TRAFFIC IMPACT ASSESSMENT

88 – 96 Mitchell Street, Bourke

0871r03v03

Table 2: Council & TfNSW RFI Comments & Where Addressed

Client	Bourke Aboriginal Corporation Health Services
Project	Bourke Integrated Primary Healthcare Centre 88-96 Mitchell Street, Bourke NSW 2840
Issue	Development Approval
Date	18/02/2025 11:00:58 AM
Scale	1:200 @A1
Drawing	Ground Plan
Drw No.	DA-02
Rev	6
Job No.	22_308
Drawn	GY
Check	AD

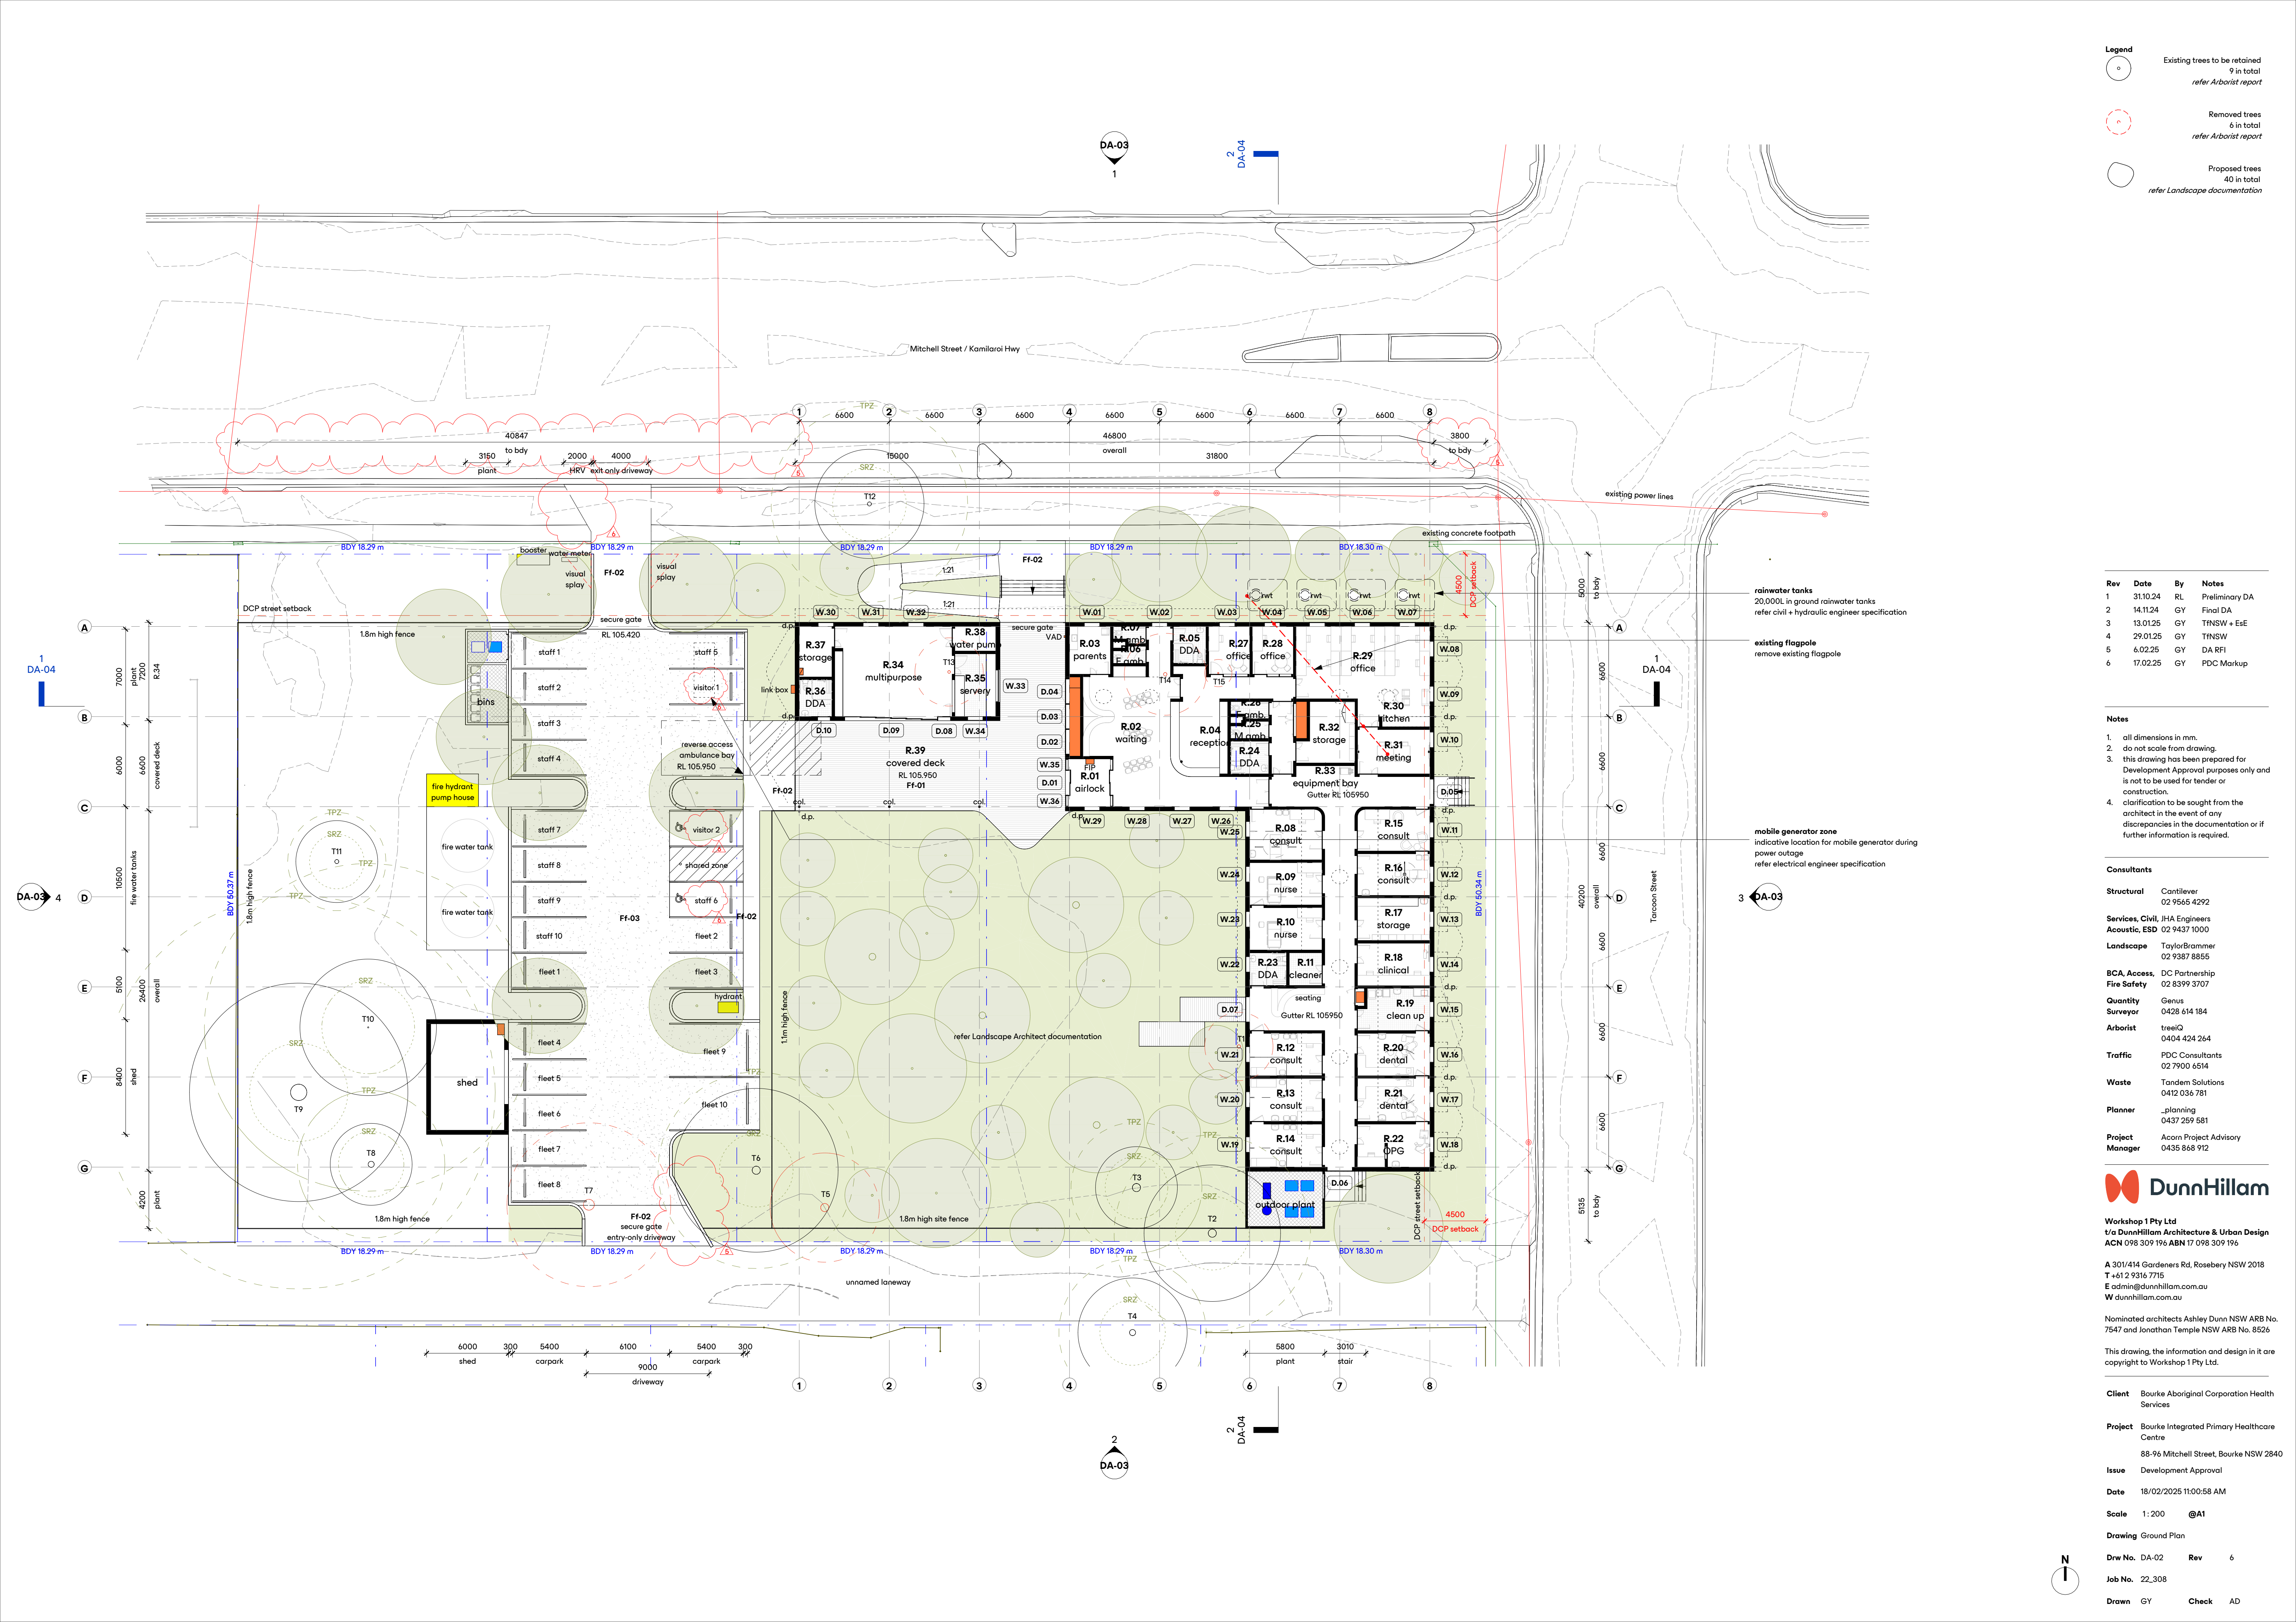
<p><u>Amend Plans</u></p> <p>Please provide amended plans that address the following matters:</p> <ul style="list-style-type: none"> Ensure all dimensions are shown on the plan set, including driveway widths and gross floor area; The exit only driveway accessing Mitchell Street should be amended to a width of 4 metres, as per the requirements of TfNSW; Include sweep paths to demonstrate that service vehicles (up to 12.5m) and emergency vehicles can safely enter and exit the subject site in a forward direct without impeding or obstructing any existing infrastructure; and A distance of 3.1m from the nearest part of the development to Essential Energy's infrastructure (measured horizontally). 	<p>Refer to the amended architectural drawings included as Appendix C.</p> <p>The exit-only driveway has a maximum width of 4 metres.</p> <p>Refer to Appendix D.</p> <p>To be addressed by others.</p>
<u>TRANSPORT FOR NEW SOUTH WALES</u>

- Ensure all dimensions are shown on the plan set, including driveway widths and gross floor area;
- The exit only driveway accessing Mitchell Street should be amended to a width of 4 metres, as per the requirements of TfNSW;
- Include sweep paths to demonstrate that service vehicles (up to 12.5m) and emergency vehicles can safely enter and exit the subject site in a forward direct without impeding or obstructing any existing infrastructure; and
- A distance of 3.1m from the nearest part of the development to Essential Energy's infrastructure (measured horizontally).

Rev	Date	By	Notes
1	31.10.24	RL	Preliminary DA
2	14.11.24	GY	Final DA
3	13.01.25	GY	TfNSW + EsE
4	29.01.25	GY	TfNSW
5	6.02.25	GY	DA RFI
6	17.02.25	GY	PDC Markup

Drawing Title
GROUND FLOOR PLAN
HEAVY RIGID VEHICLE SWEEP PATH ANALYSIS
ENTRY AND EXIT MOVEMENT

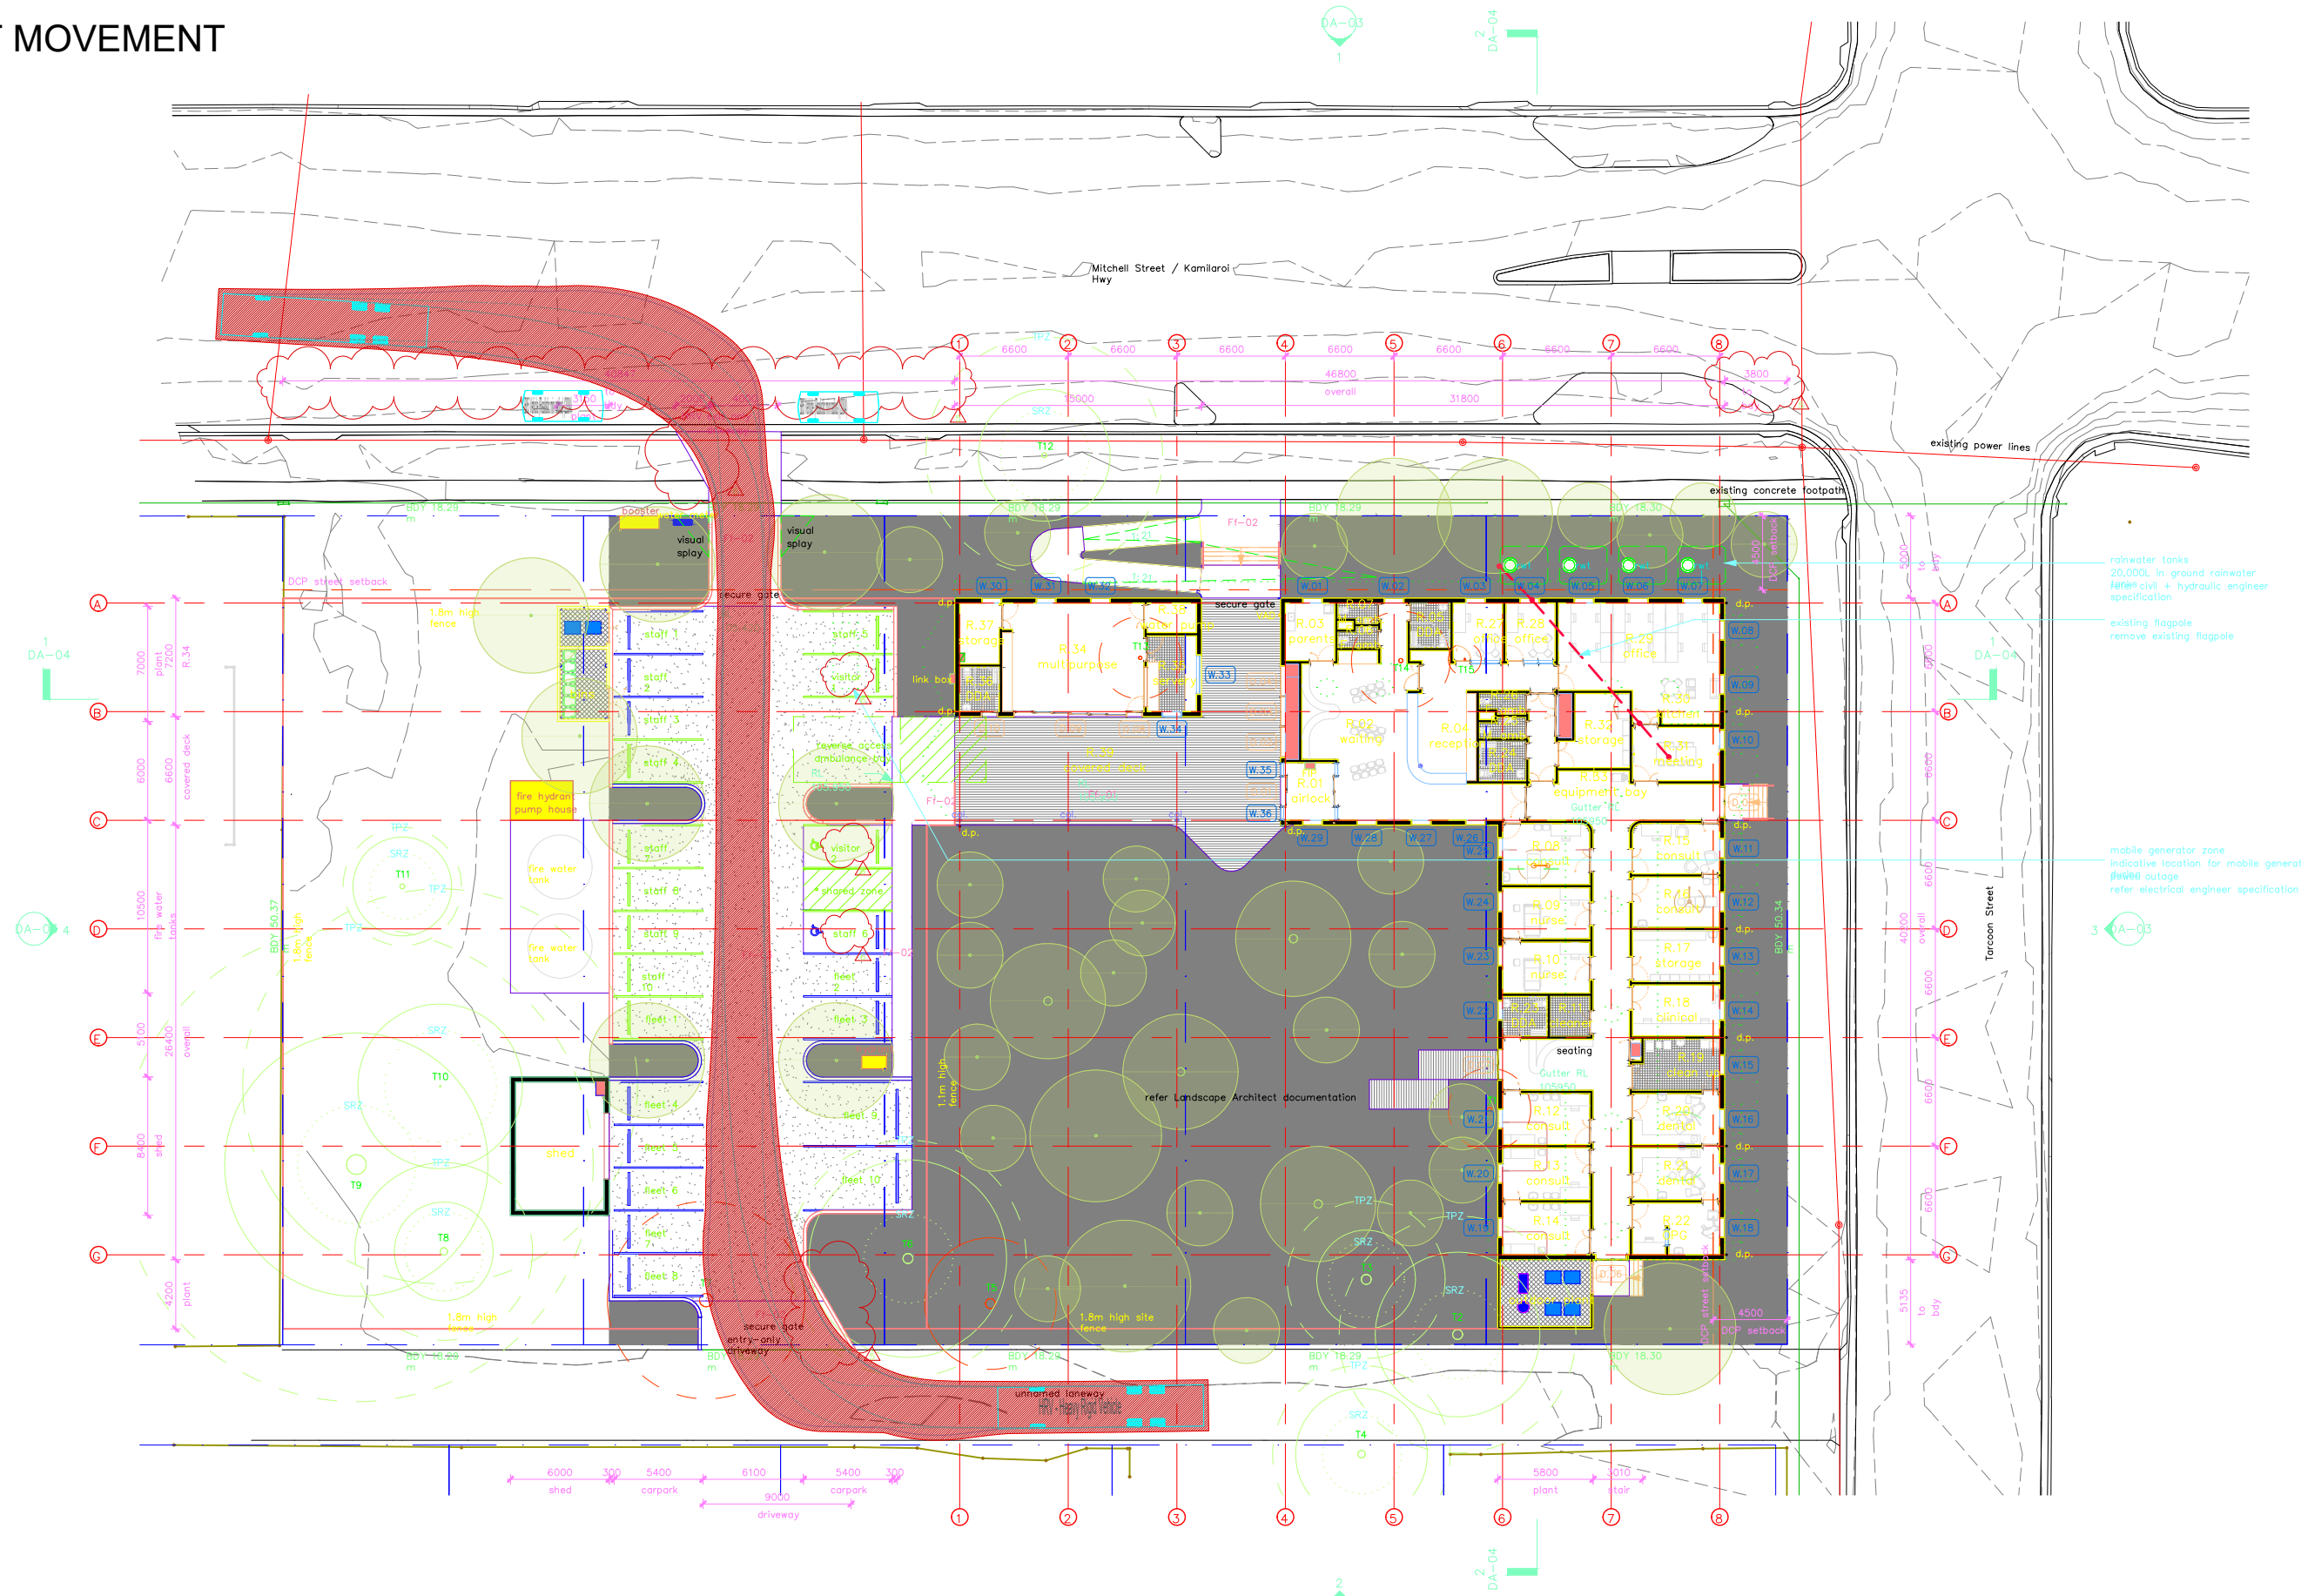
COMMENTS	WHERE ADDRESSED / RESPONSE
<p>Visitor Parking Management</p> <ul style="list-style-type: none"> The two designated visitor parking bays are identified as accessible parking spaces. Please clarify how parking will be managed for visitors who do not hold appropriate permits to use accessible bays. 	<p>Per the amended architectural drawings included as Appendix C, the parking allocation has been revised to allow for one designated accessible space for visitors and one standard car space.</p>
<p>Matters raised by TfNSW:</p> <ul style="list-style-type: none"> Transport for NSW (TfNSW) have stated that prior to determination Council must be satisfied that service vehicles (up to 12.5m) and emergency vehicles can safely enter and exit the subject site without impeding or obstructing any existing infrastructure. Please provide amended plans with sweep paths to demonstrate that this requirement can be satisfied. 	<p>Refer to Appendix C and D</p>

Transport for NSW (TfNSW) have stated that prior to determination Council must be satisfied that service vehicles (up to 12.5m) and emergency vehicles can safely enter and exit the subject site without impeding or obstructing any existing infrastructure. Please provide amended plans with sweep paths to demonstrate that this requirement can be satisfied.
